REV.	REVISION	DATE
1	1st DRAWN	05/03/04
2	AMENDED	13/07/04
3	4th TOOL INFO ADD	21/02/13

TITLE: **JACK SOCKET S1C/S/BBBX2/SPN/NNW**

DRWG. No. **FCR1117**

NEW TOOL 4

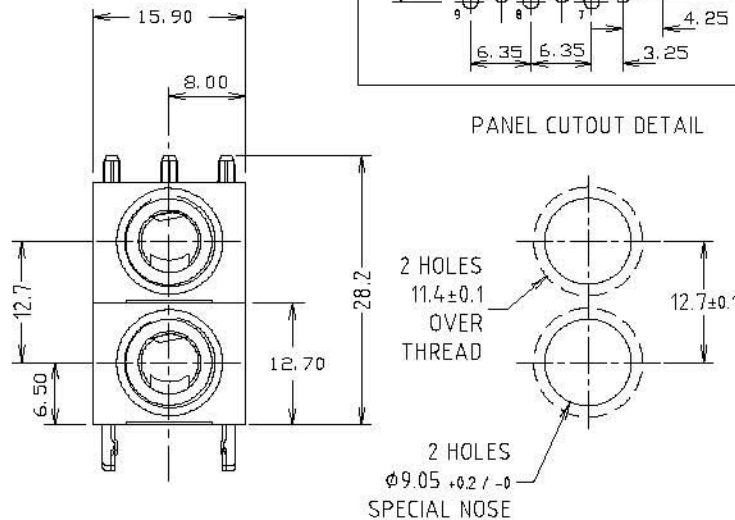
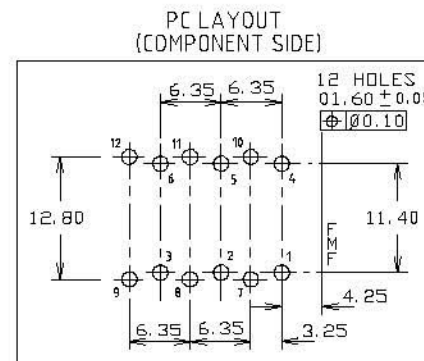
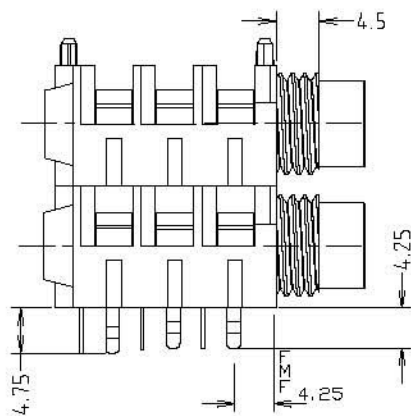
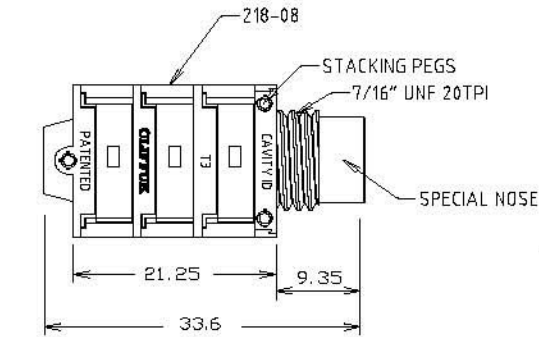
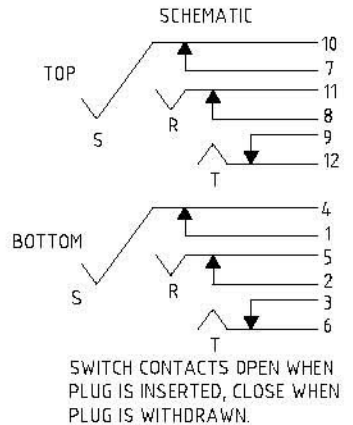
- 1) ADDITIONAL JACK PLUG SUPPORT
- 2) TYPE 2 CONTACTS
- 3) SPECIAL NOSE THREAD LENGTH 5.0mm
- 4) PATENT NUMBER WILL BE ON PACKAGING
- 5) CAVITY ID NEXT TO CLIFF LOGO.

NOTE:
 DUPLICATE TOOLING MAY BE USED FOR THIS JACK SOCKET.
 TOOL 3 AS SHOWN, T3 ID ON MOULDINGS
 TOOL 4 (NEW) - SEE IMAGES AND NOTES.
 NO NUTS OR WASHERS ARE SUPPLIED WITH THIS MODEL.

IMAGES ARE OF FCR1126L - SPACER IS NOT USED ON FCR1117.
